ADDENDUM NO. 2
CONTRACT NO. CP8126-1 – GENERAL, MECHANICAL AND
ELECTRICAL CONSTRUCTION
 DATED: SEPTEMBER 27, 2010

SUFFOLK COUNTY DEPARTMENT OF PUBLIC WORKS
DIVISION OF SANITATION
HAUPPAUGE INDUSTRIAL PARK
S.C.S.D. NO. 18 – INDUSTRIAL SEWER DISTRICT EXPANSION
SUFF 0503

SHEET P4 - SKETCH # 17

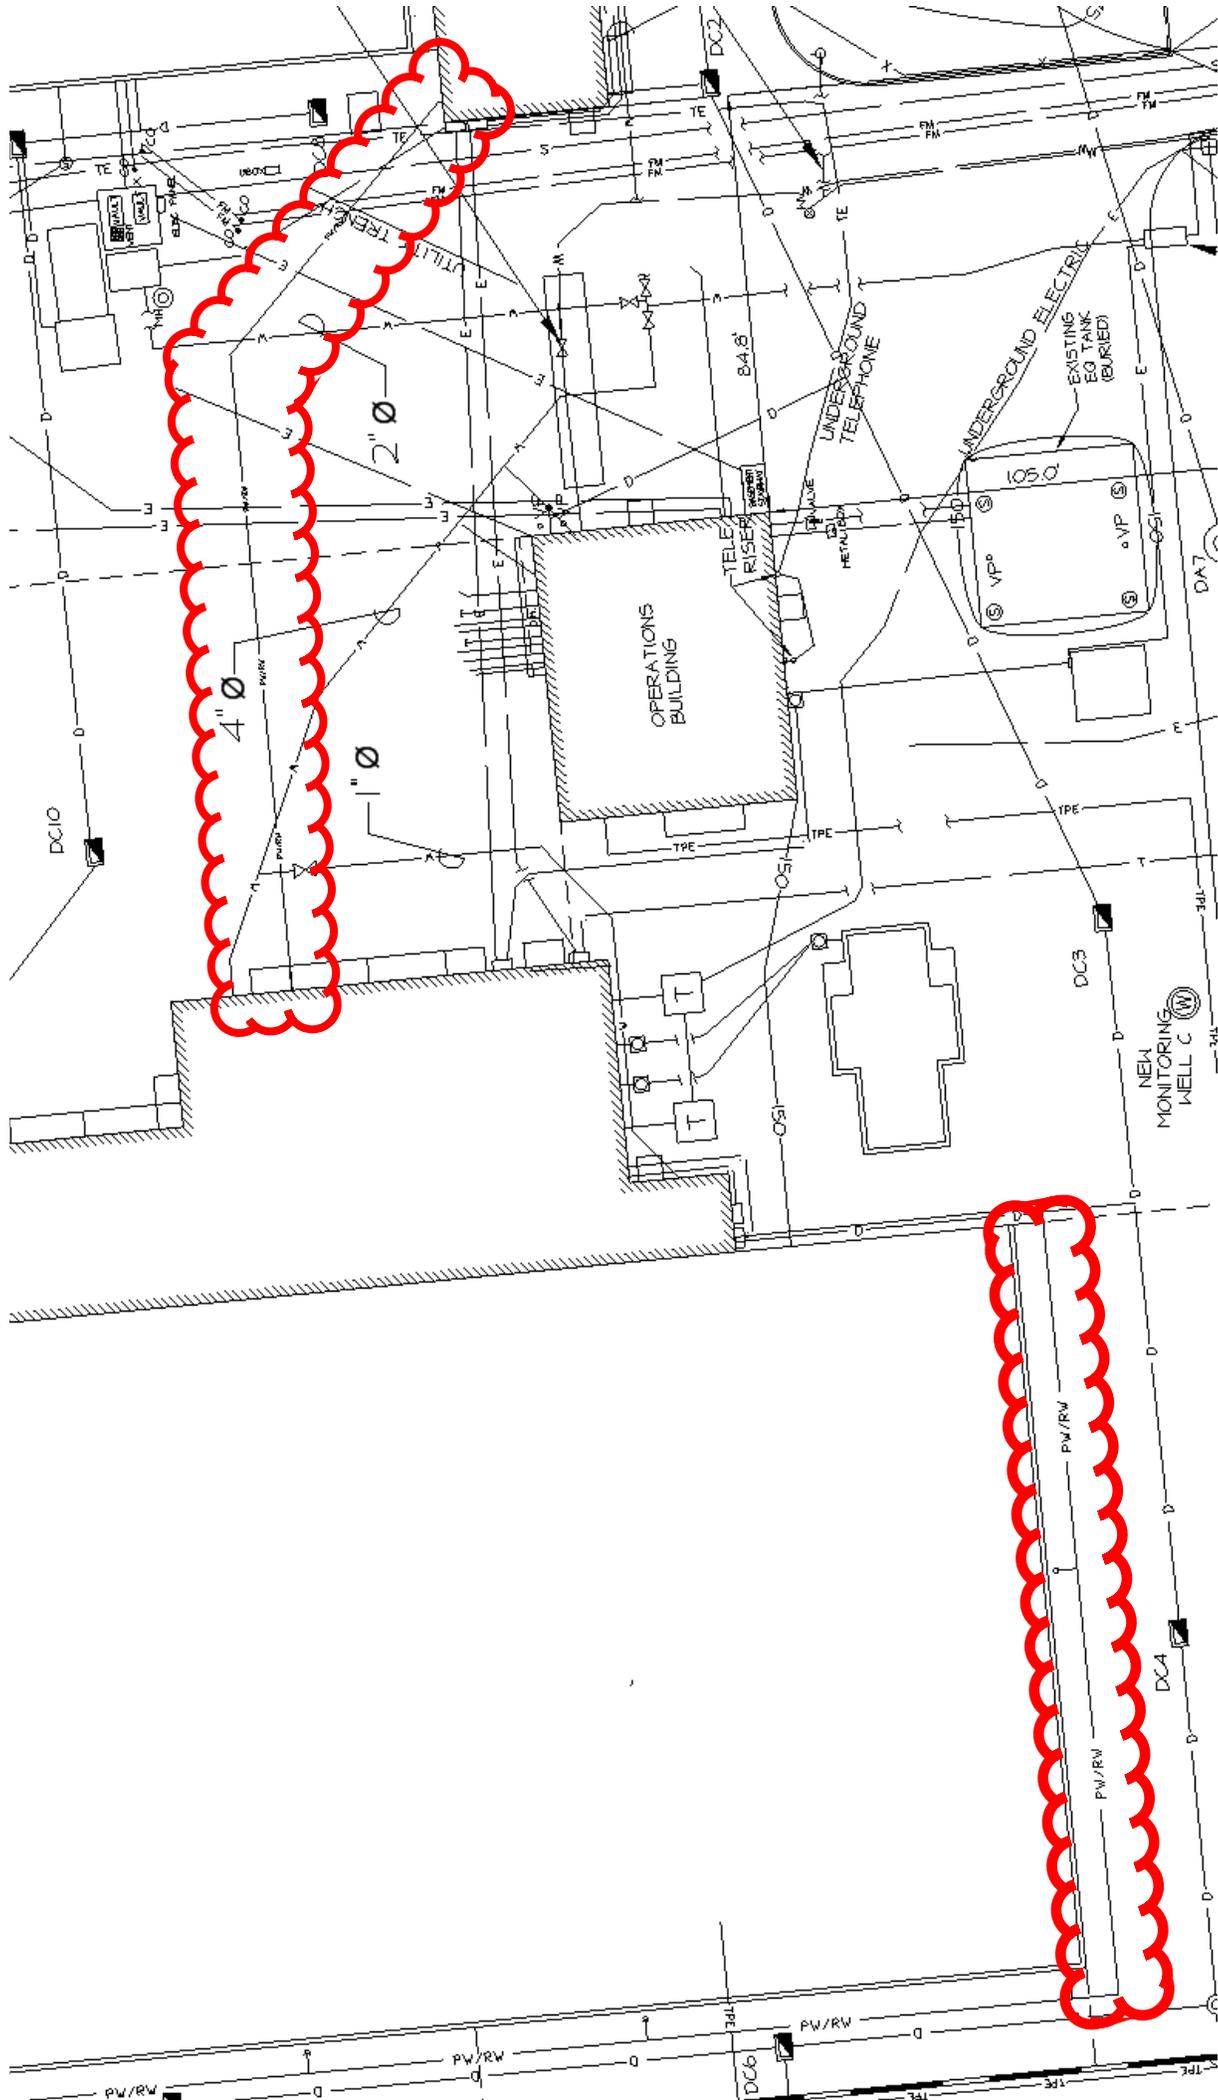
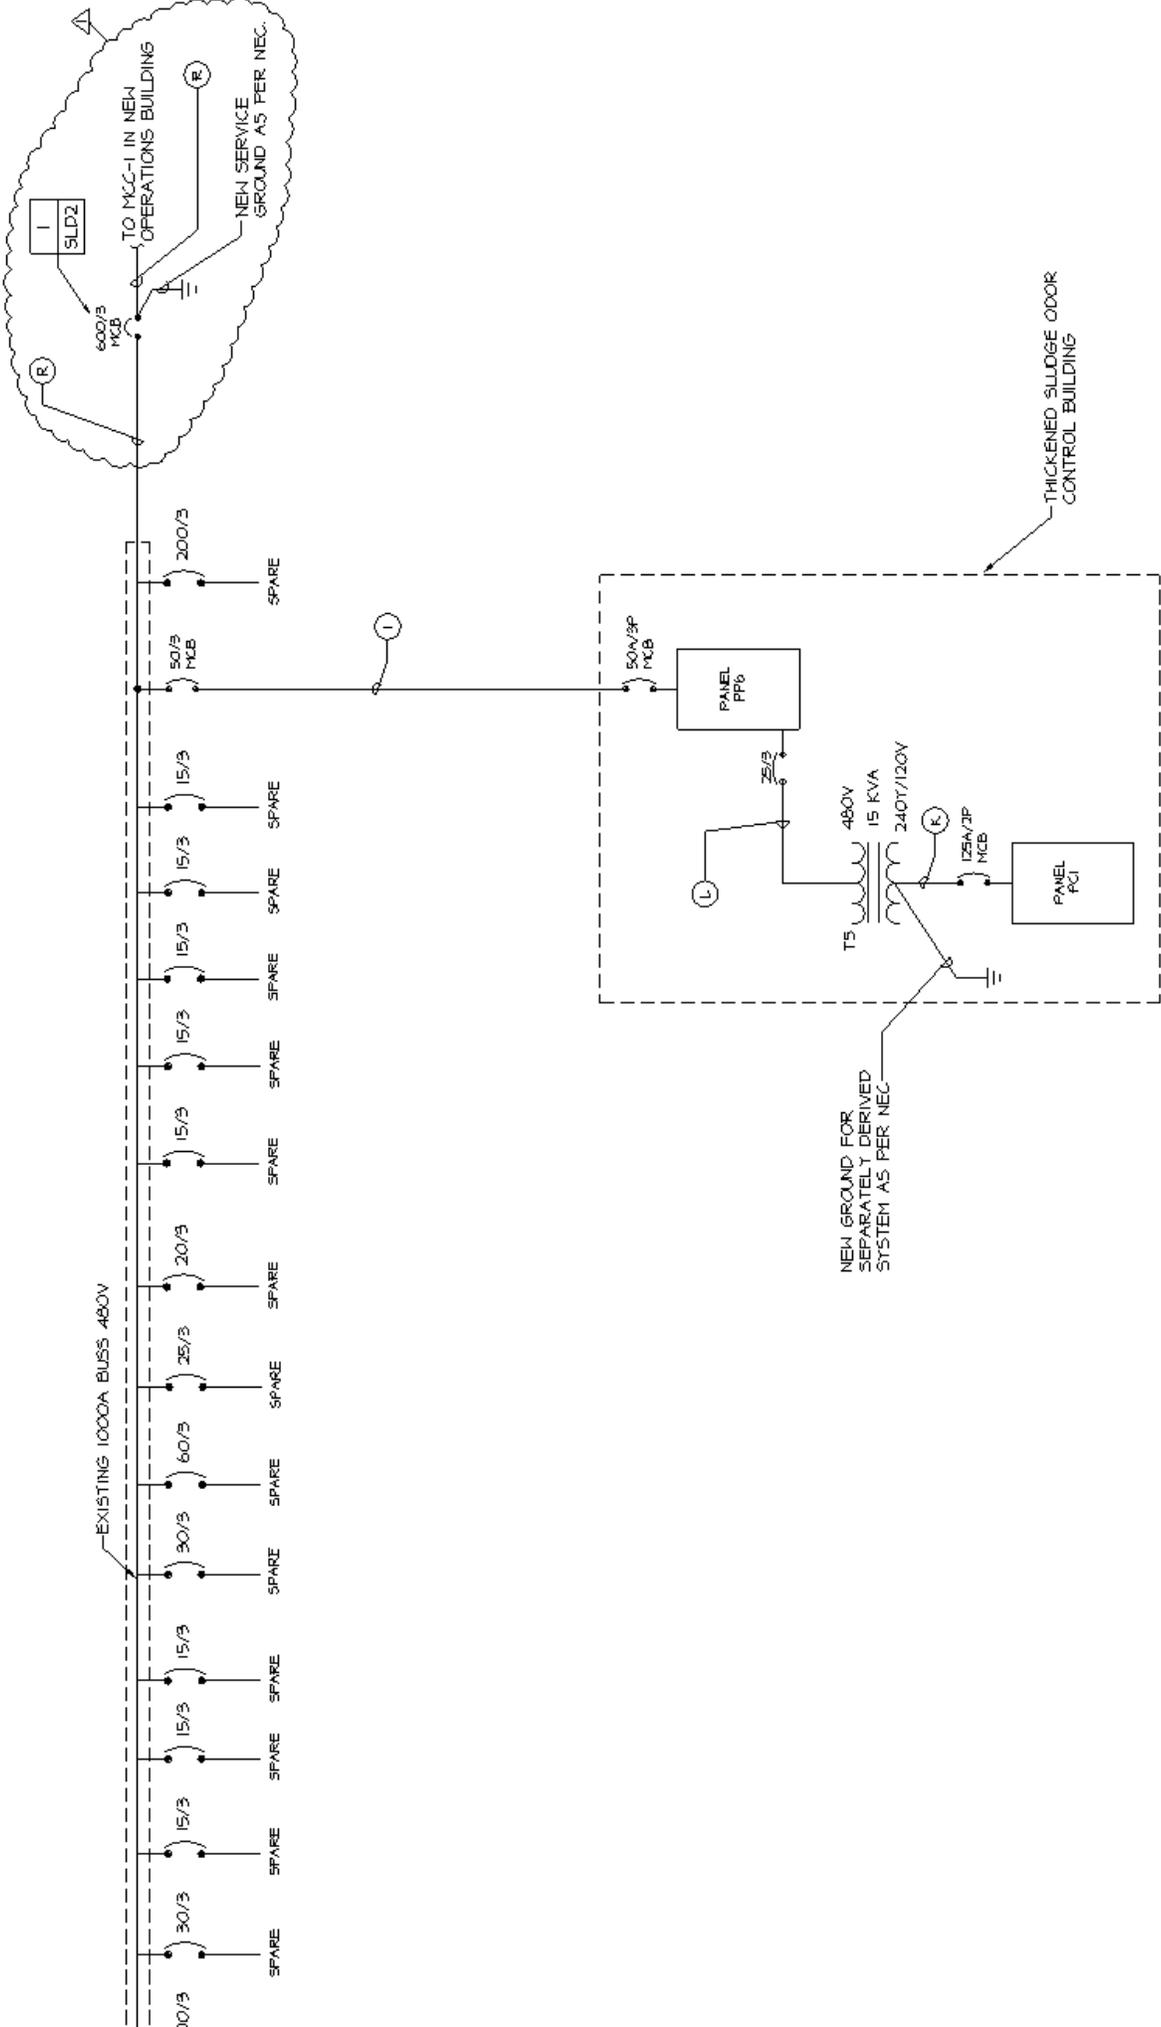
1. Show routing of plant/recycled water from Operations Building to Headworks Building.
2. Modify callout of water line(s) labeled “PW” to “PW/RW”.
3. Above revisions as shown on Sketch #17 included herein.

SUFF 0503
ADDENDUM #2 - ITEM AA
SHEET SLD2 - SKETCH # 18

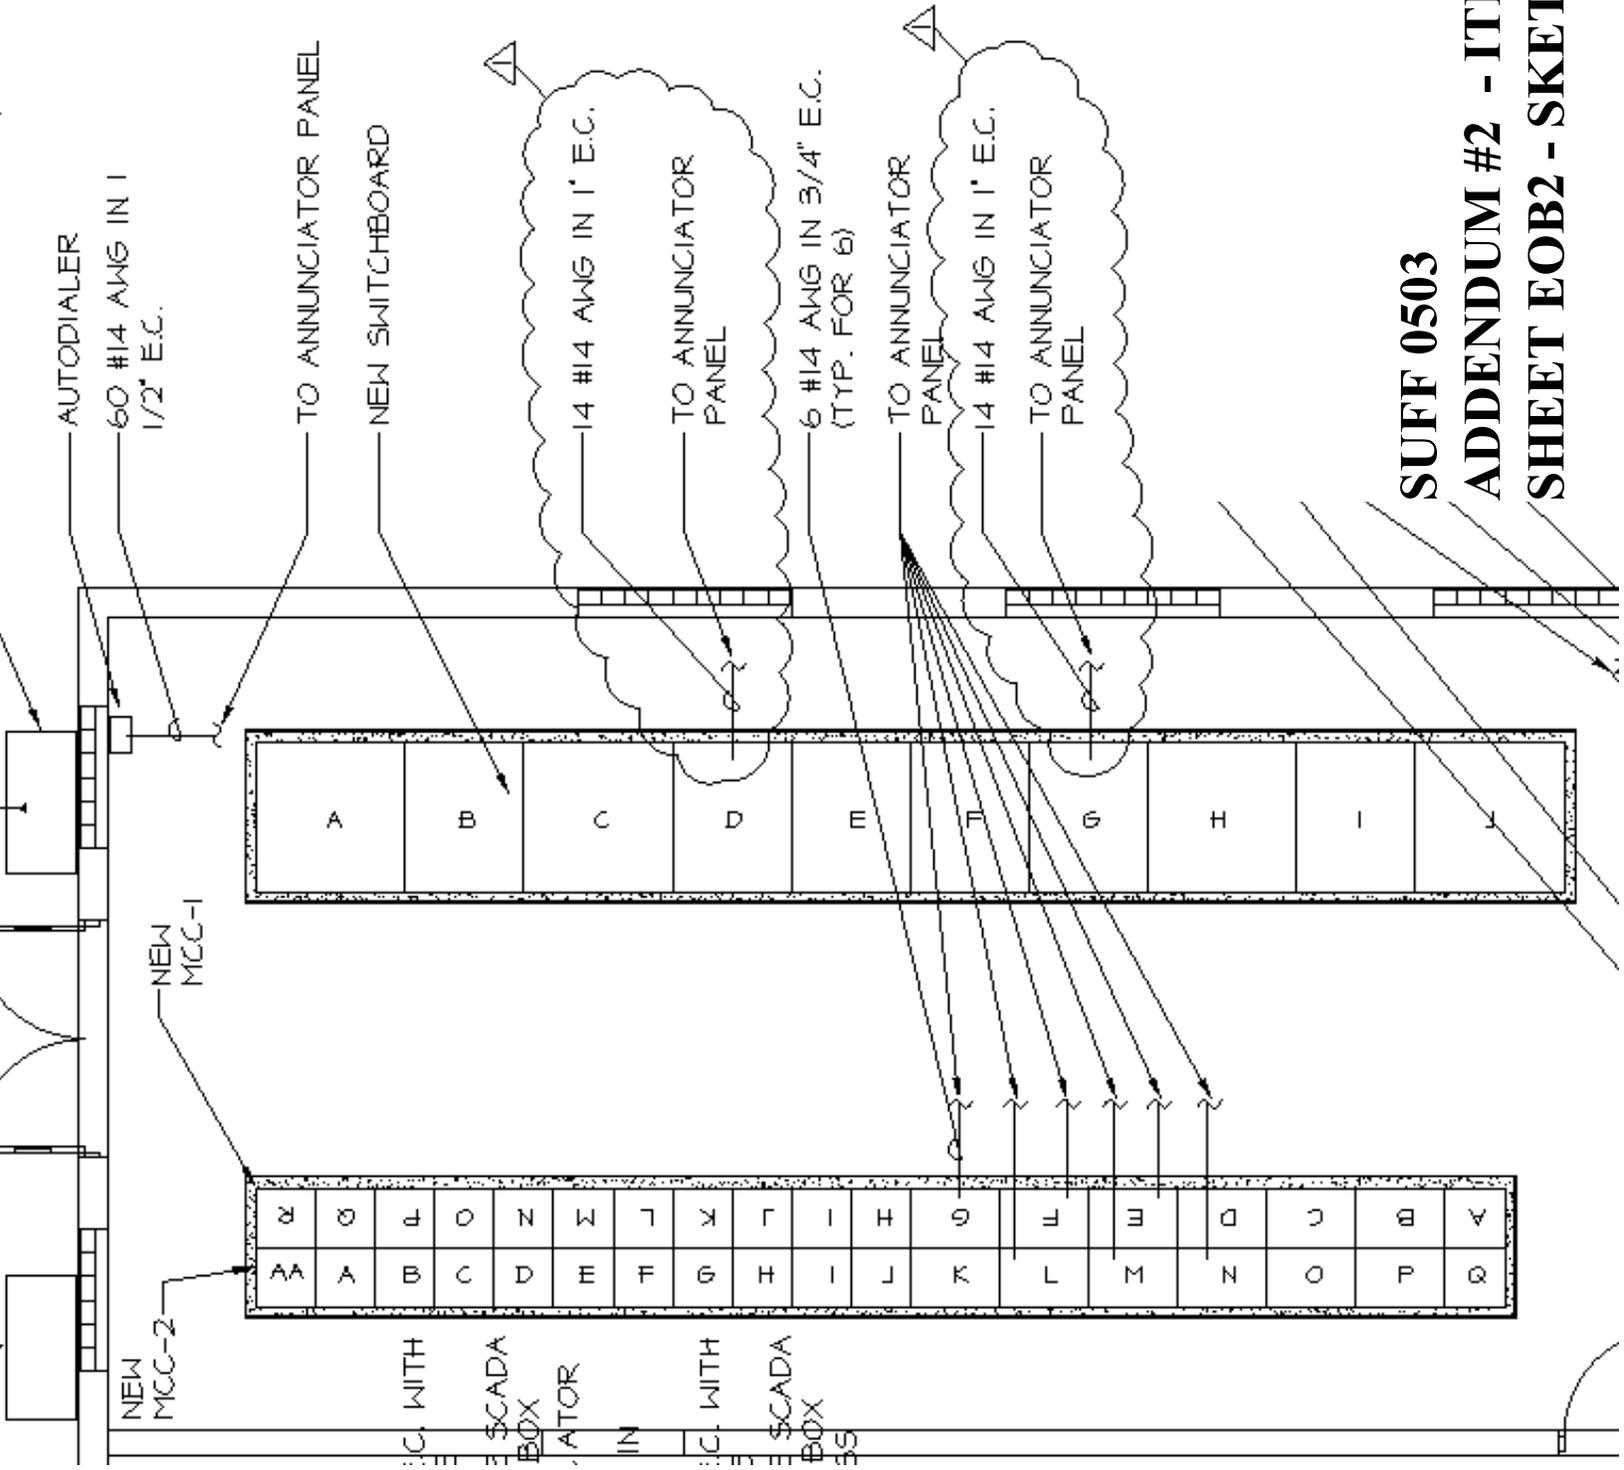
1. Update callout of Modified Existing Single Line Diagram showing connection “TO MCC-1 IN NEW OPERATIONS BUILDING”.
2. Modify the wiring callout on both sides of the 600/3 MCB from “T” to “R”.
3. Above revisions as shown on Sketch #18 included herein.

SHEET EOB2 - SKETCH # 19

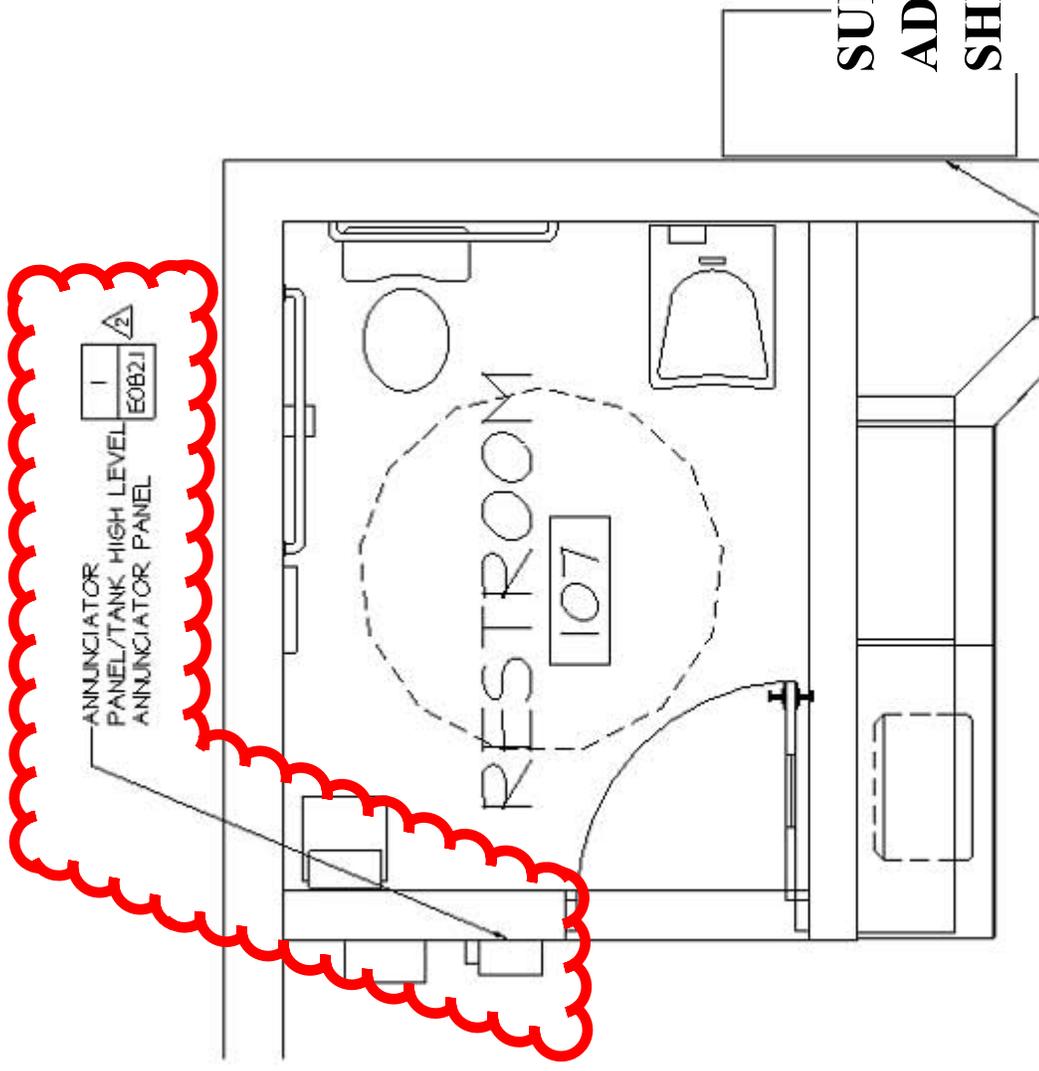
4. Modify the quantity of #14 AWG wire in the electrical conduit from “AUTODIALER” to the “ANNUNCIATOR PANEL” from “60” to “84” and increase conduit size from “1 ½-inch” to “2-inch”.
5. Increase number of 1-inch spare conduits with drag wires from “future STB” to “HEADWORKS BUILDING via control pullbox” from “4” to “18”.
6. Insert new wiring from switchboard sections “D” and “G” to annunciator panel with callout “14 #14 AWG IN 1” E.C.”. (see sketch #19 included herein)

**ADDENDUM #2 - ITEMS HH1 & HH2
SHEET EOB2.1 - SKETCH # 20**

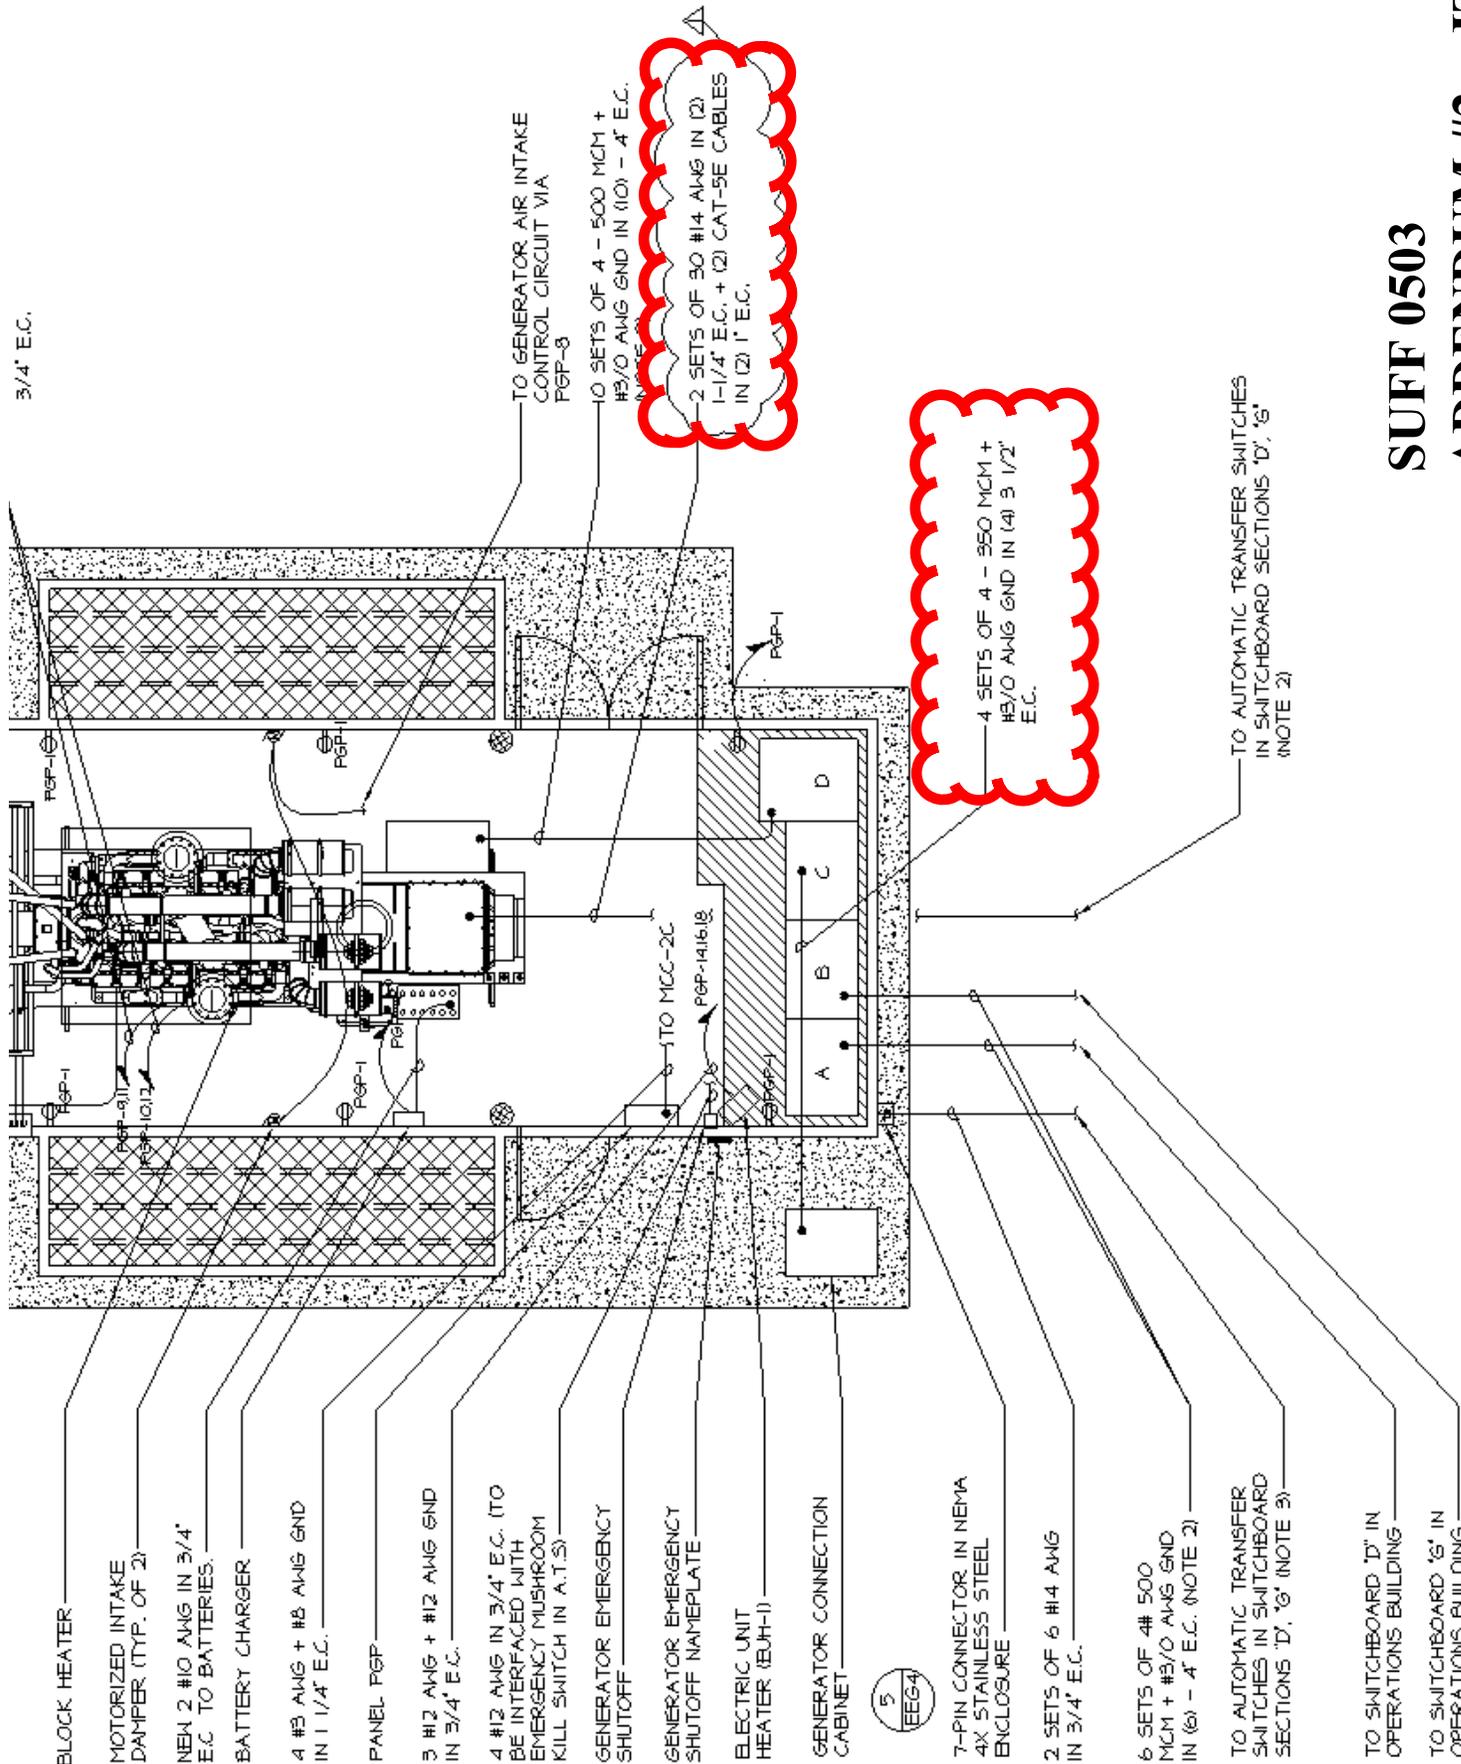
1. Modify callout for the annunciator panel to read: “ANNUNCIATOR PANEL/TANK HIGH LEVELS ANNUNCIATOR PANEL” and shift leader to panel closest to the restroom door.
2. Add the following Note 1: “TANK HIGH LEVELS ANNUNCIATOR PANEL to be mounted below the ANNUNCIATOR PANEL. Provide 84 #14 AWG in 2-inch diameter electrical conduit between the two panels.”
3. Modify the quantity of #14 AWG wire in the 1-inch electrical conduit from CP-1 to the ANNUNCIATOR PANEL from “10” to “24”.
4. Modify the quantity of #14 AWG wire in the ¾-inch electrical conduit from CP-3 to the ANNUNCIATOR PANEL from “10” to “18”.
5. Modify callout of wiring from CP-1 to multiple MCC buckets to read: “(5) sets of 20 #14 AWG in (5) 1” E.C. +”.
6. Items 1 and 2 above are shown in sketch #20 included herein.
